NAC INTERNATIONAL

September 20, 2000

Subject: Information Supplement in Response to the NRC Question on NAC-UMS® Universal Transport System Responses to RAI-1 on the Scale Model Side Drop Test (TAC No. L22452)

Information Supplement
UMS Scale Model Side Drop Test Results

Figure 1. Overall Model Plot for the UMS Quarter Scale Model

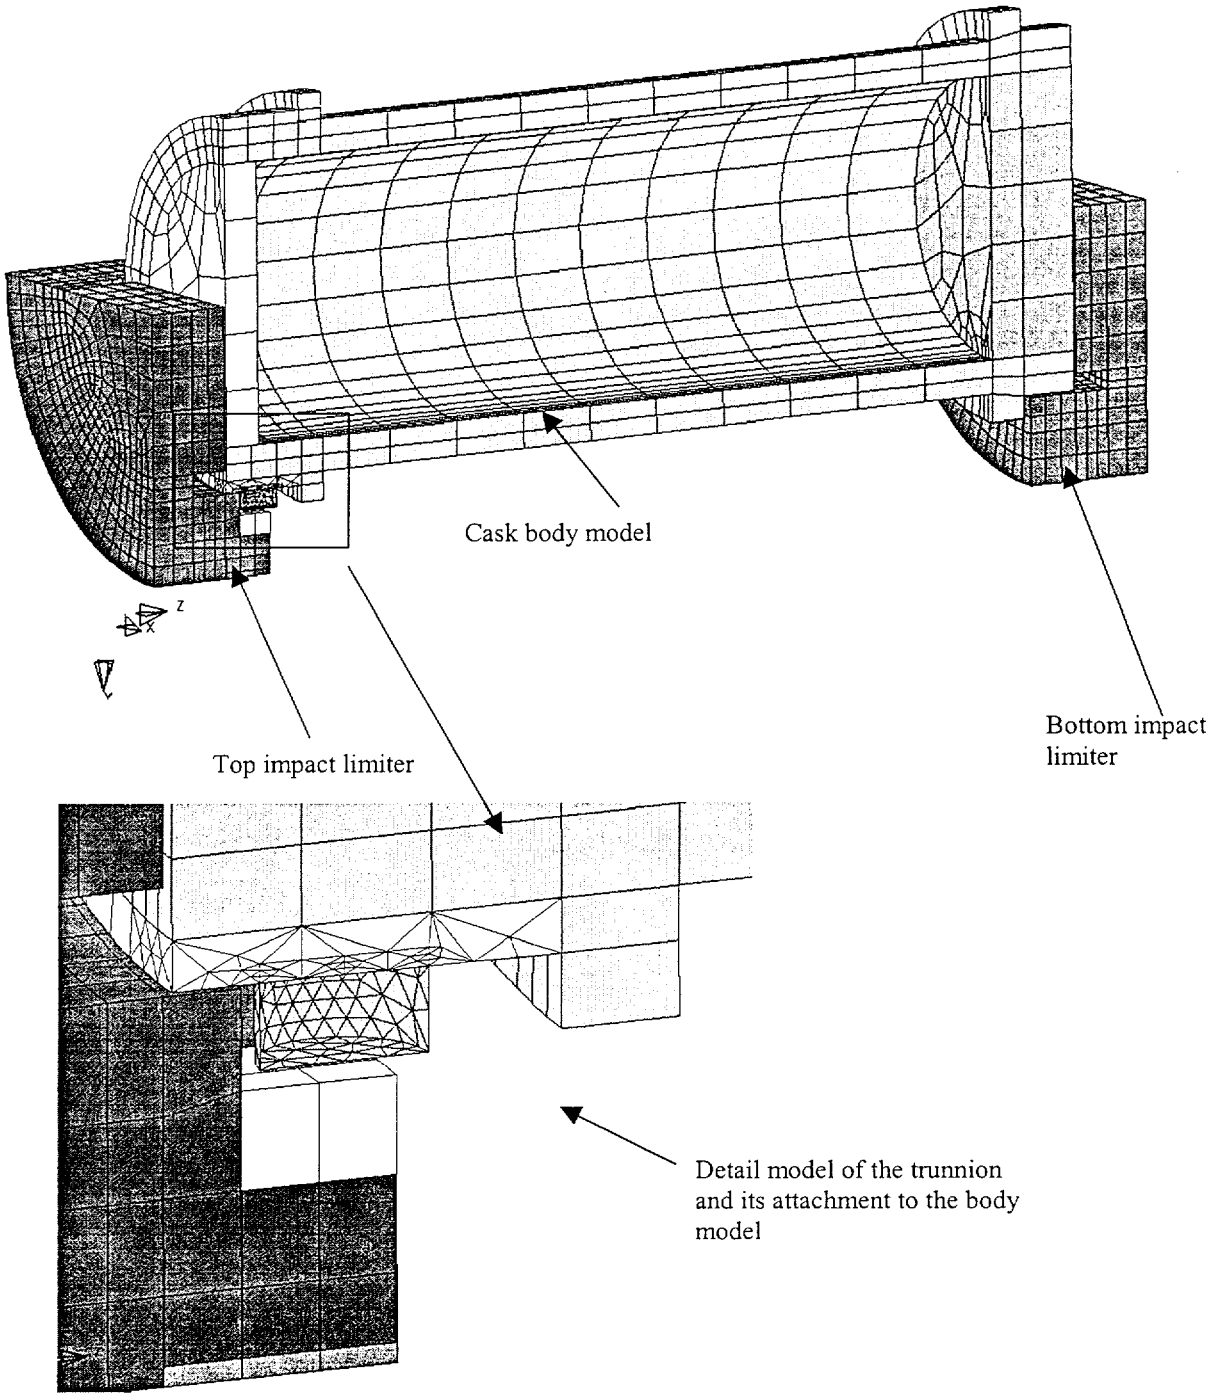
To examine the effect of removing the elastic response from the quarter scale model during the 30 foot side drop, an LS-DYNA model was constructed as shown in Figure 1. This model includes the top and bottom limiter as well as the body. Due to symmetry of the cask, only one half of the cask is modeled for this analytical evaluation. Symmetry boundary conditions were applied at the plane of symmetry. In this analysis, the body was made rigid by selecting the LS-DYNA rigid body option for the cask materials. Since the cask body was made rigid, further simplification of the model was permitted by distributing the concentrated weights of the scale model internals onto the body shell, while still maintaining the total weight and CG. The cask body used in this analysis also contains a trunnion, in which the model trunnion dimensions corresponds to the actual trunnion dimensions for the scaled model (Figure 1, detail). The trunnion in the model was represented by rigid shell elements. This modeling simplification did not affect the crushing of the redwood material and resultant cask response.

Figure 2. Model Plots for the Top Impact Limiter and Bottom Impact Limiters for the UMS Quarter Scale Model

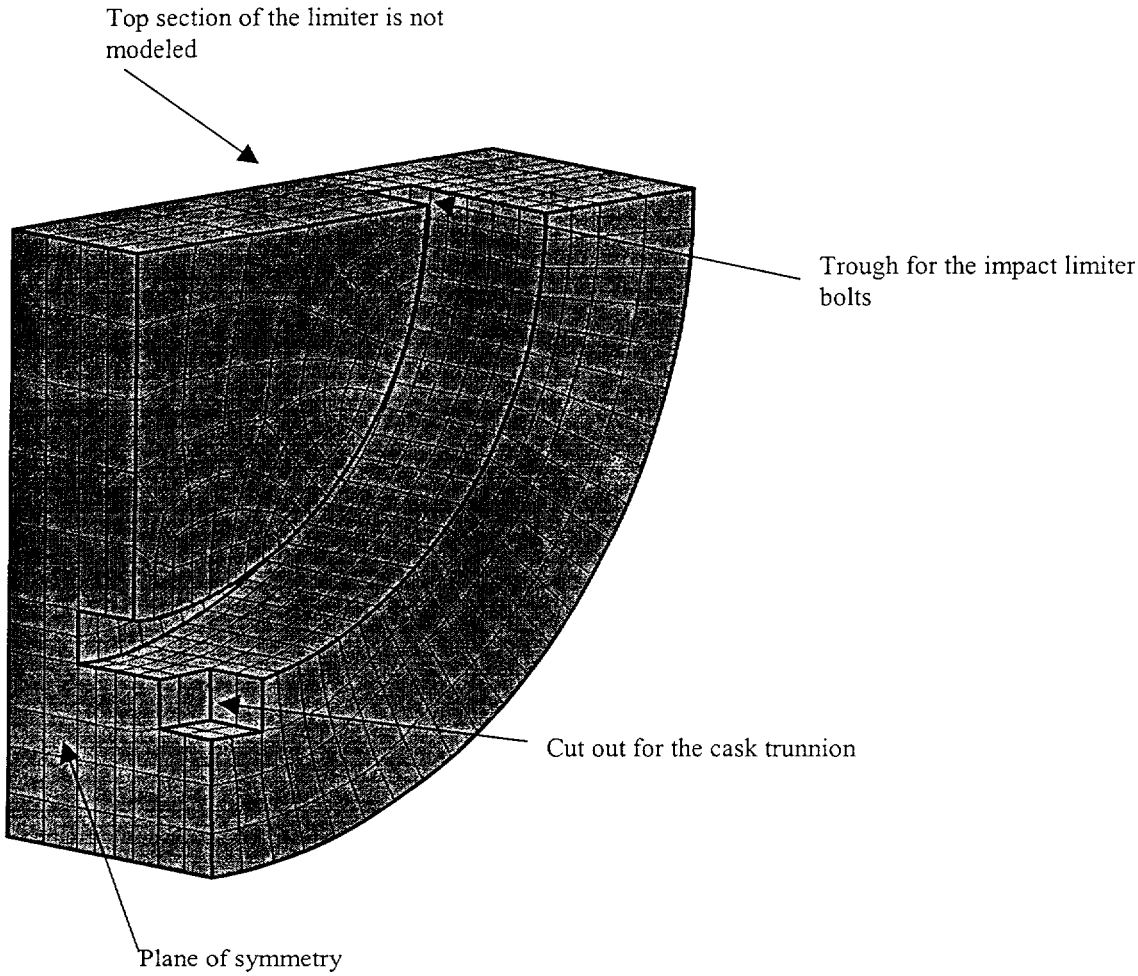
The significant feature of the actual limiter is the section of the impact limiter that experiences crush and decelerates the cask model. For this reason, without any degradation of the ability to model the impact limiter crushing, the detailed models of the limiters did not contain the upper half section of the limiter as shown in Figure 2. The dimensions used in the model correspond to those contained in the above referenced drawings for the quarter scale model. The top limiter (in Figure 2) shows that the cut out for the trunnion was modeled to accurately represent the redwood under the trunnion. The bottom impact limiter design and finite element model do not contain this type of cut out. Redwood parallel to grain properties are defined for the impact limiter material. The properties are taken at ambient temperature condition, representing actual test conditions. The impact plane is modeled as an unyielding surface. The analysis condition for this model included the following:

Figure 3. Acceleration Traces for the Rigid Body Model

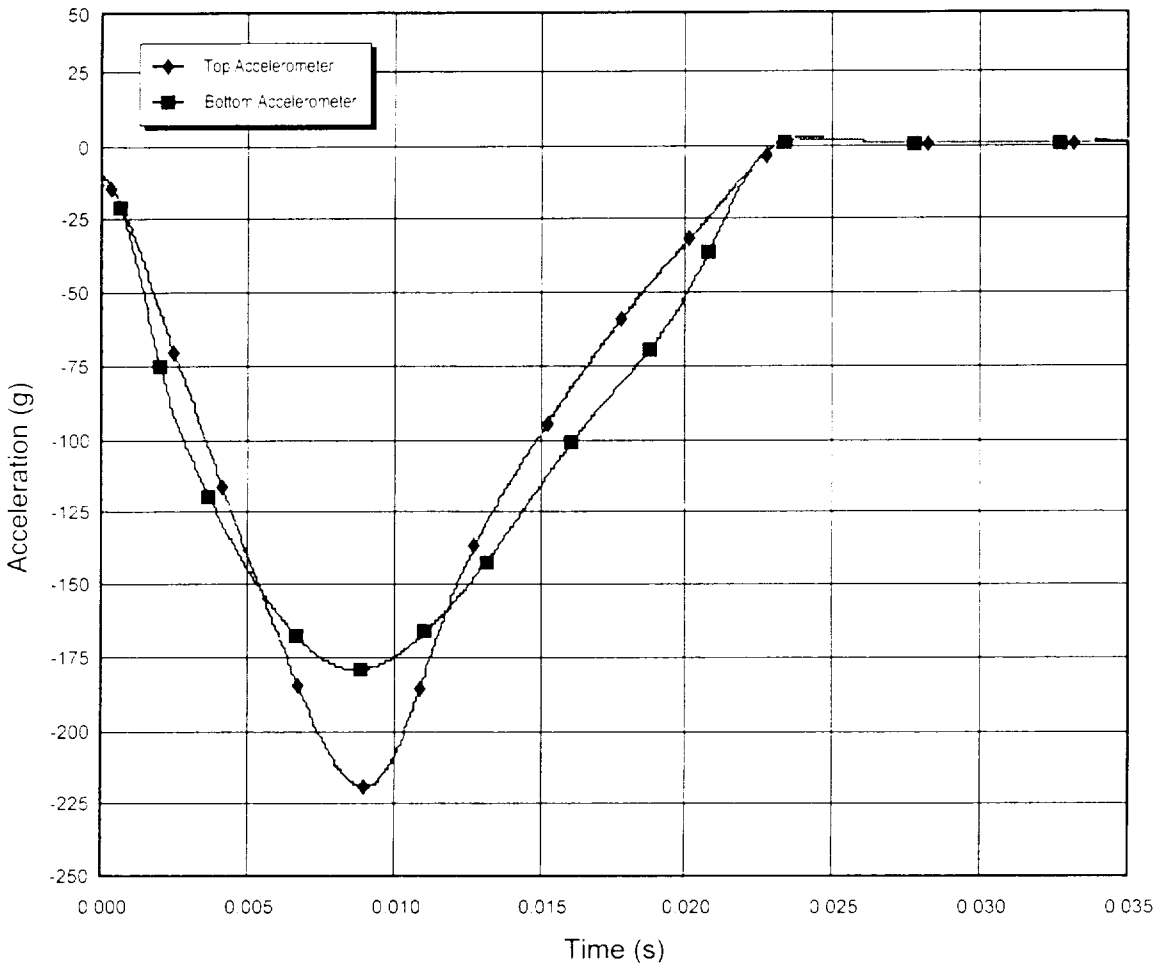
Two acceleration time histories were extracted at positions corresponding to the top and bottom accelerometers used in the drop tests. The acceleration traces are shown in Figure 3. These traces do not exhibit any positive peaks at the end of the drop test. The maximum accelerations were reported to be 219 g's and 180 g's for the top and bottom locations respectively.

Figure 4. Acceleration Traces for the Elastic Model of the Quarter Scale Model

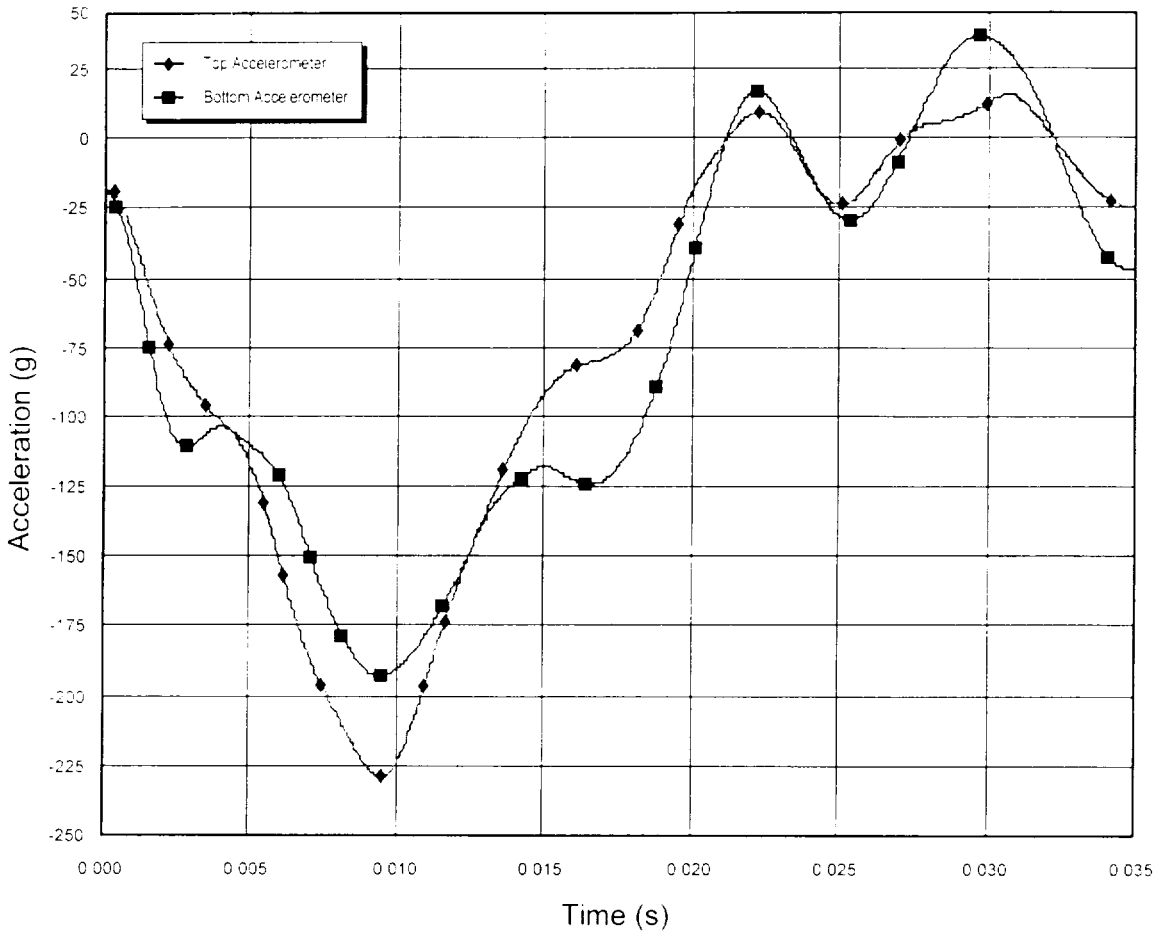
To examine the effect of the concentrated weight and the elastic response of the system, the LS-DYNA model used in the first analysis was modified to include elastic properties and concentrated mass. Elastic properties for the main part of the body were used and the lump masses for the disks were also used. The detailed portion of the model for the trunnion and its attachment to the body remained rigid components. This would not affect the elastic response of the system. The same conditions used for the rigid model were also used in this evaluation. The acceleration traces for the top and bottom locations are shown in Figure 4. The maximum accelerations are shown below.

The elastic condition shows a positive peak, or the indication of the elastic response of the model resulting in a rocking condition. This behavior does not appear in the rigid case. This elastic and concentrated mass LS-DYNA model yields approximately 12% larger negative acceleration than the average (204g) for the top location. The top and bottom results indicate that the LS-DYNA values are conservative for the controlling negative values, which occur in decelerating the model. While the positive peaks from the analysis are not as large as those observed in the test, the analysis does show that an elastic effect does result in a rocking motion. Since the rigid model would not contain the effect of a concentrated mass, it would be concluded that the rocking motion is due to the concentration of the masses in conjunction with the elastic body. It is noted that such concentration of the weights is not representative of the package design.
